Safety Recall

Code: 42L1

REVISION

Subject Rear Axle Trailing Arm Lock Nut

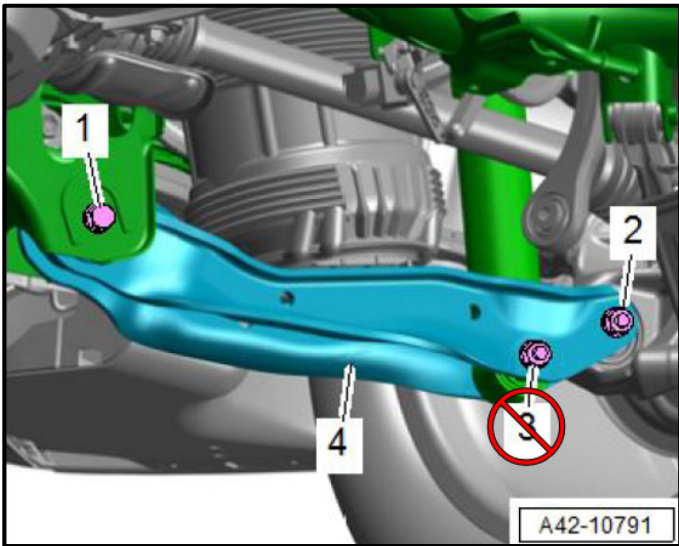
REVISION SUMMARY Updated wheel bolt torque specification for Q5

A6 and A7 Models	
Model	Torque Specification
All models	120 Nm
A8 Models	
Model	Torque Specification
All models	120 Nm
Q3 Models	
Model	Torque Specification
All models	140 Nm
Q5 Models	
Model	Torque Specification
All models	140 Nm
Q7 and Q8 Models	
Model	Torque Specification
All models	160 Nm
